**WNP5 - Replacing Drain Hose on Heating/Fresh-Air Unit (Workshop Campaign)**

Revision: This bulletin replaces bulletin Group 8 67/23 WNP5, dated June 5, 2023.

Model Line: **Cayenne (92A)**

Concerns: **Drain hose on heating/fresh-air unit**

*Installation position of drain hose on heating/fresh-air unit*

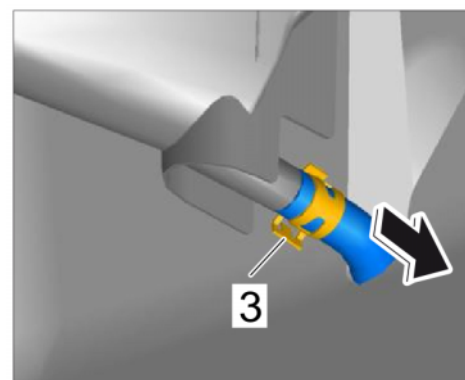
Cause: **A drain hose not manufactured according to specifications may have been installed on the heater/fresh-air unit on affected vehicles.**

If so, it cannot be ruled out that condensation may accumulate in the air conditioning drainage system during regular operation and over the service life of the vehicle. As a result, moisture can enter the vehicle interior via the footwell ventilation duct.

Action: Replace the drain hose on the heating/fresh-air unit.

**Arrow** – Drain hose on heating/fresh-air unit (**Replacing**)

Note the installation position of the drain hose ⇒ *Drain hose*. The new drain hose must be installed in this position.

3.1 Loosen spring band clamp ⇒ *Pulling off drain hose -3-* and pull the drain hose off the heating/fresh-air unit.

*Drain hose seating*

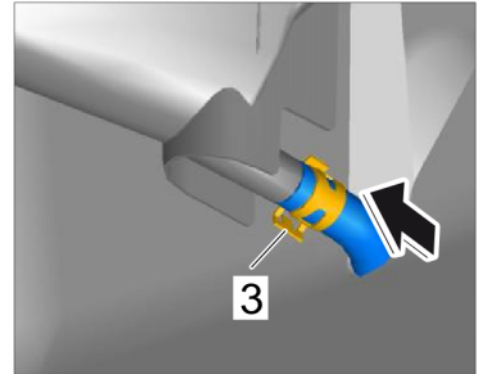
9 From the underbody of the vehicle, ensure again that the drain hose is seated correctly.

Lug ⇒ *Drain hose seating -1-* must point upwards and drain hose opening ⇒ *Drain hose seating -2-* must point downwards. It is also important that the drain hose is seated correctly along entire groove ⇒ *Drain hose seating -Arrow-* in the body wall. Tighten the drain hose from below if necessary.
